Cogentrix Quail Brush Generation Project - Docket Number 11-AFC-03: Responses to CEC Staff Data Requests 87 through 89

QUAIL BRUSH GENERATION PROJECT (11-AFC-3)

Responses to Energy Commission Staff's Data Requests 87 through 89

TECHNICAL AREA – TRANSMISSION SYSTEM ENGINEERING

FIGURE 1.1-3A
138 KV LINE BREAK (TL13822)
PREFERRED ROUTE PLAN
AND PROFILE

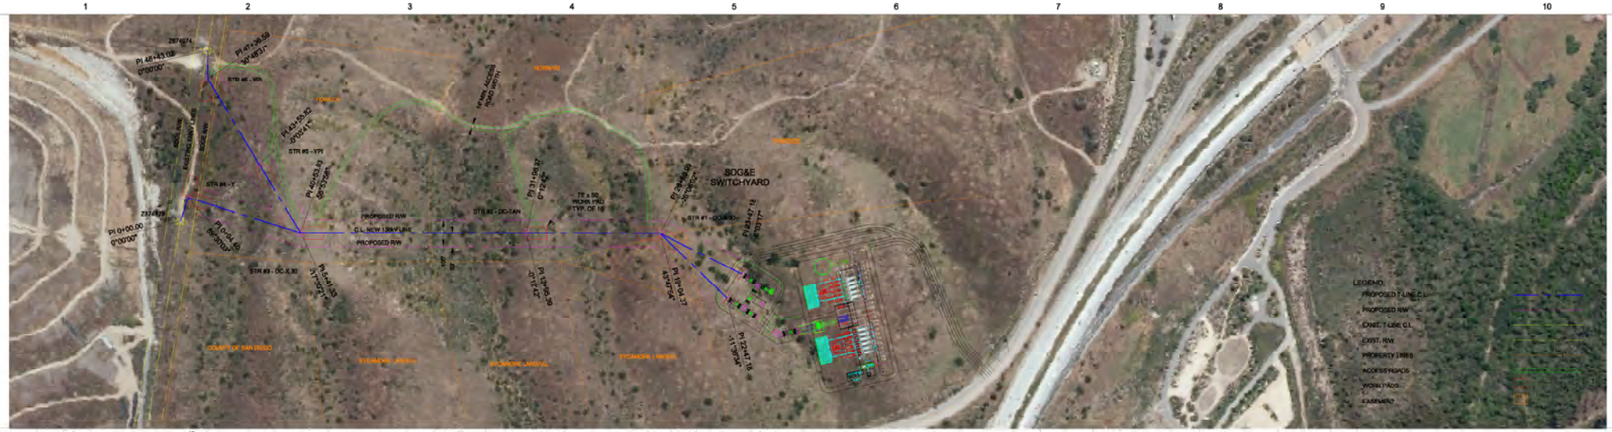
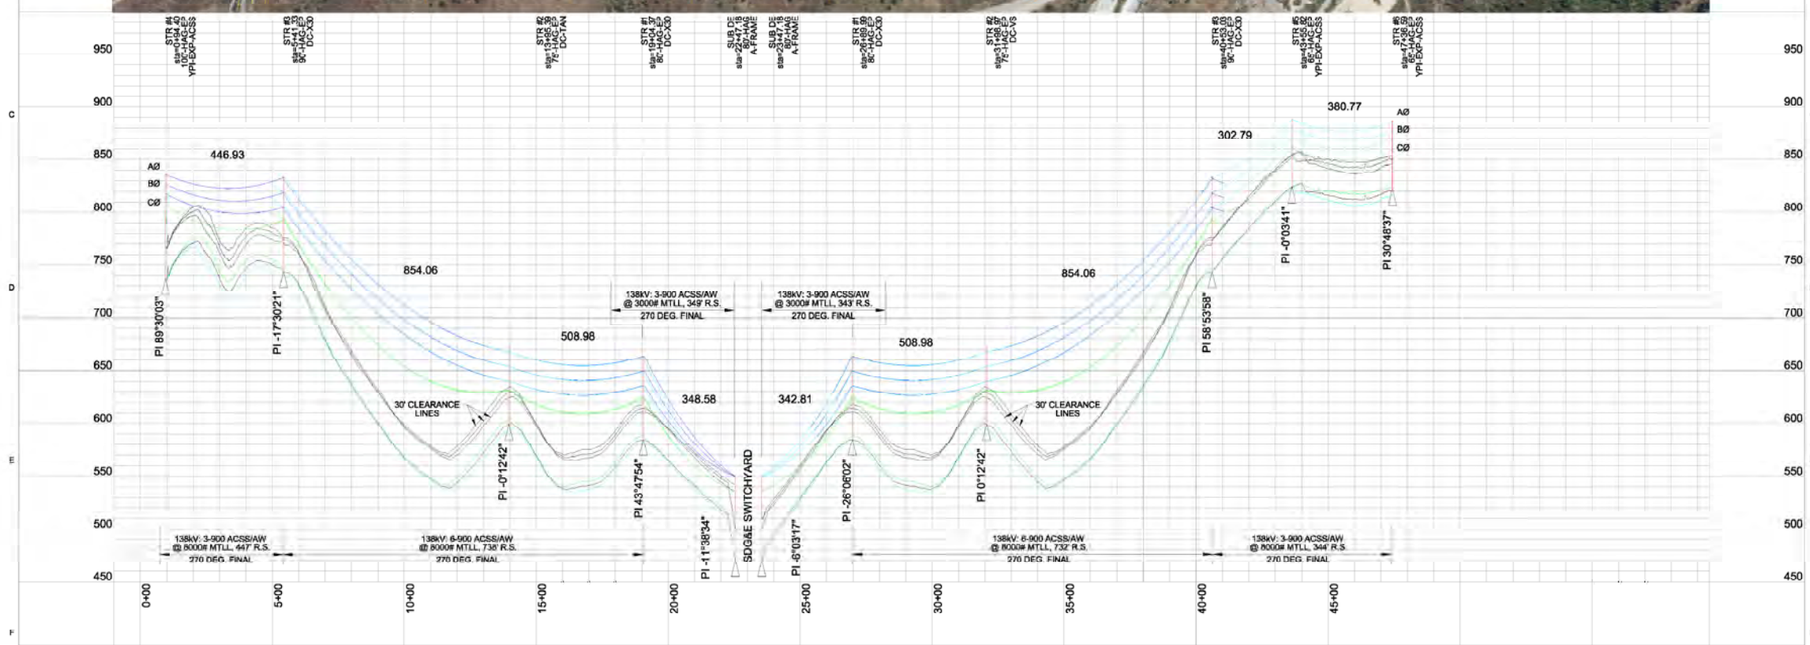
88. Data Request: Please provide a physical layout drawing (final or tentative) showing distinctly (in a larger scale) the preferred and alternate #1 routes (along any roads, land or overhead line corridor) of the proposed 138 kV overhead loop lines between the proposed SDG&E 138 kV switchyard and the existing Mission-Carlton Hills 138 kV line. The drawing should show the existing or proposed road widths, ROW widths and any proposed extended (spur) road widths along with alignment of the proposed loop lines. Describe whether the ROWs would be through any private and/or public lands.

As the result of progress made in ongoing design effort, a new route has been developed for the loop lines between the SDG&E Switchyard and the 138 kV line break of TL13822. This revised route contains improvements over the previously submitted Preferred Route and Alternate 1 described in Supplement 3 Figures 1.1-3 and 1.1-4. These improvements include reduced pole heights that reduce visual impacts. This final route is shown on Figure 1.1-3A and Figure 1.1-3B in Attachment A of this submittal. These figures are intended to supersede Figures 1.1-3 and 1.1-4 from Supplement 3 to the AFC. This plan and profile drawing contains a scaled plan view of the proposed route with main and spur access roads highlighted in green, a 100-foot right-of-way (ROW) highlighted in pink, and property lines highlighted in orange. All ROWs will be through private land.

The attached plan and profile drawing (Figure 1.1-3A) shows the new proposed route for loop lines between the SDG&E switchyard and the 138 kV line break. This drawing contains a profile of the route with pole locations, pole and conductor elevations, and identifies each pole by structure number. The following drawings provide design details for each of the poles utilized along the route.

FIGURE 2.3-1A
138 KV LINE BREAK
STR. #1 DC-X TYPE

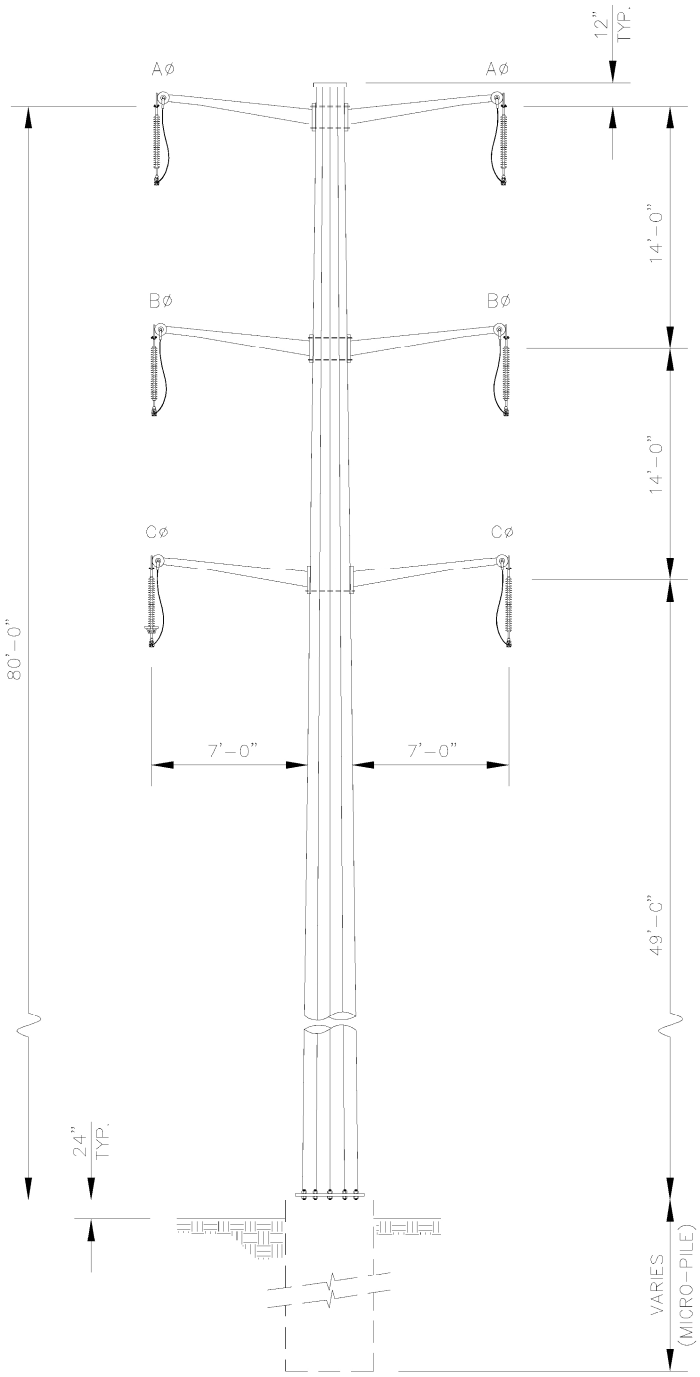
89. Data Request: For single circuit loop lines construction, submit tangent steel pole design diagram (or resubmit Figure 2.3-1) showing configuration (vertical or triangular) of insulators, phase and ground conductors with their respective position measurements on the pole including ground clearance from the lowest conductor and height of the pole above ground. Also include design diagrams of dead-end and angle steel poles with the above mentioned information (or resubmit Figures 2.3-2 and 2.3-3).

For the double-circuit loop line construction with vertical configuration of insulators and conductors, provide design diagrams for tangent, dead-end and angle steel poles with the information as stated above. Also mention the name of the builder (the applicant or SDG&E) for the proposed loop lines.

1. Figure 2.3-1A: design diagram for Structure #1, a double-circuit X-type steel pole
2. Figure 2.3-1B: design diagram for Structure #2, double-circuit steel tangent pole
3. Figure 2.3-1C: design diagram for Structure #3, double-circuit X-type steel pole
4. Figure 2.3-1D: design diagram for Structure #4, single-circuit Y-type steel pole
5. Figure 2.3-1E: design diagram for Structure #5, single-circuit YPI-type steel pole
6. Figure 2.3-1F: design diagram for Structure #6, single-circuit YPI-type steel pole

These figures are intended to supersede Figures 2.3-1, 2.3-2, and 2.3-3 from Supplement 3 to the AFC. The design basis for loop lines is to maintain minimum ground clearance of 30 feet from the lowest phase conductor. The Applicant shall be the builder for the loop lines in compliance with SDG&E requirements.

FIGURE 4A
QUAIL BRUSH KEY ONE-LINE DIAGRAM

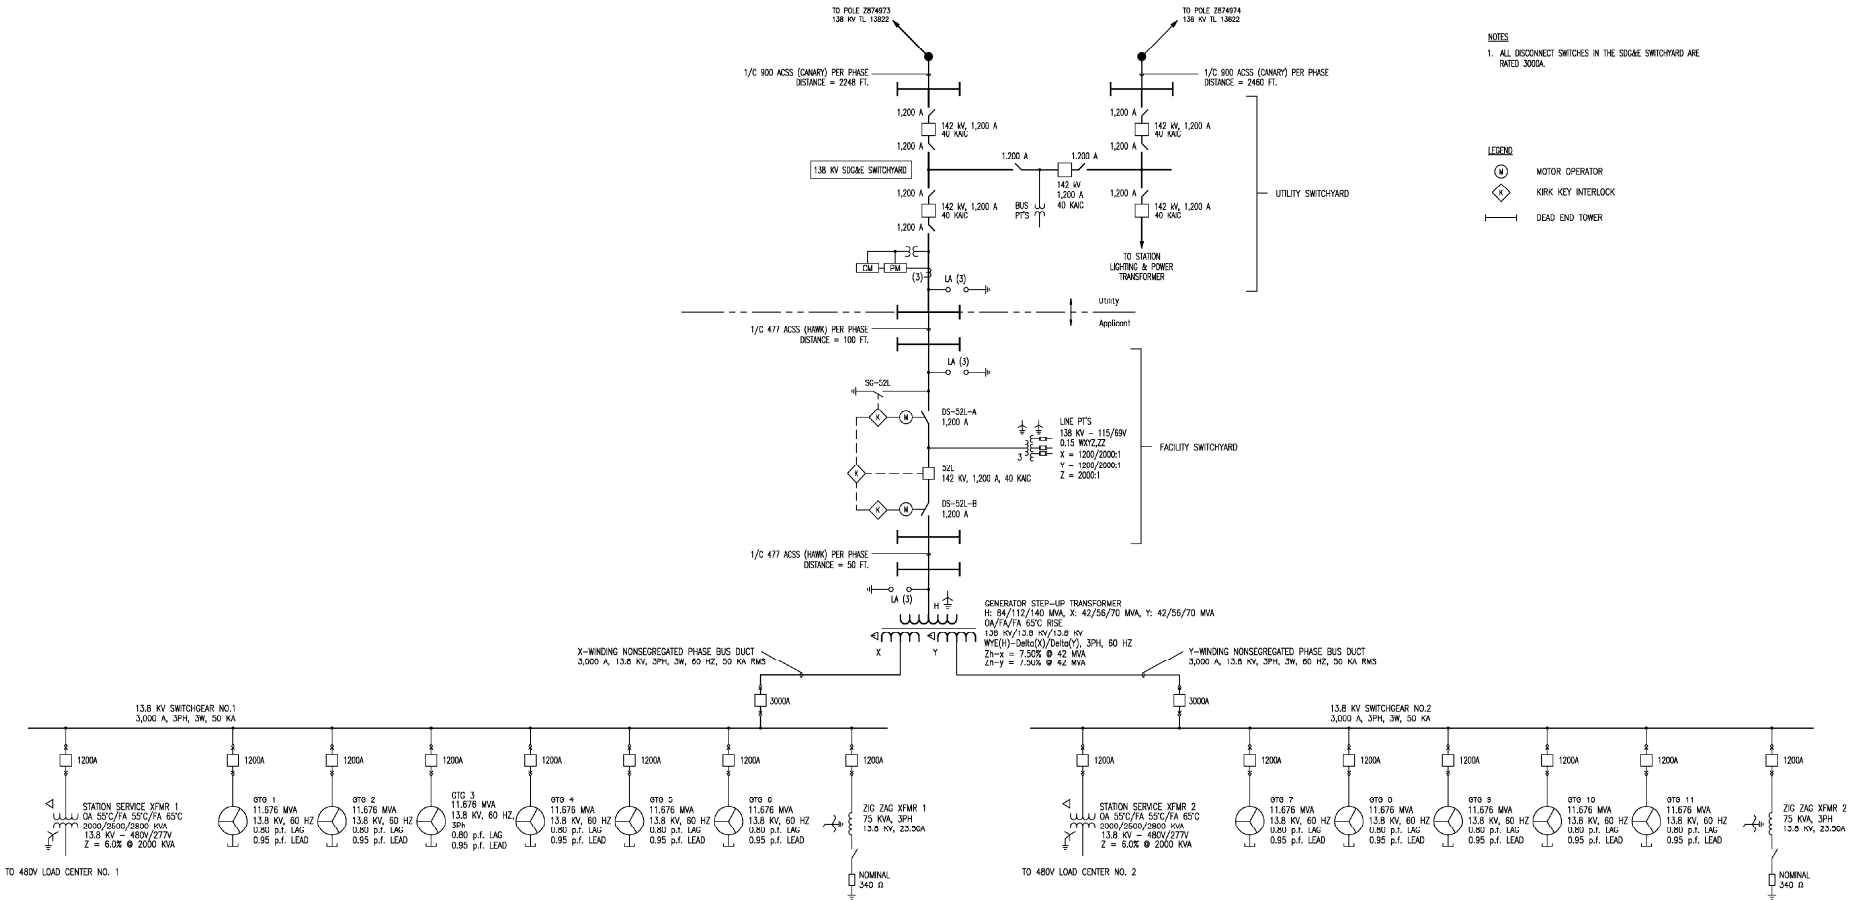
87. Data Request: Please provide a complete one-line electrical diagram (final or tentative pending final) of the proposed SDG&E 138 kV switchyard with the transmission outlets showing configuration of buses, breakers with disconnect switches along with their respective sizes, ampere and voltage ratings. Also mention the name of the builder (the applicant or SDG&E) for the proposed SDG&E switchyard.

The attached drawing "Exhibit 4A: Quail Brush Key One Line Diagram" depicts the proposed four (4) element, single-bus, single-breaker switching arrangement of the SDG&E 138 kV Switchyard. This exhibit is intended to supersede Exhibit 4 from Supplement 1 to the AFC. This is a preliminary drawing that includes the radial bus switching scheme with transmission outlets (3), high voltage circuit breakers and associated disconnect switches, along with their ampere and voltage ratings. The Applicant will construct the SDG&E Switchyard in compliance with SDG&E requirements.
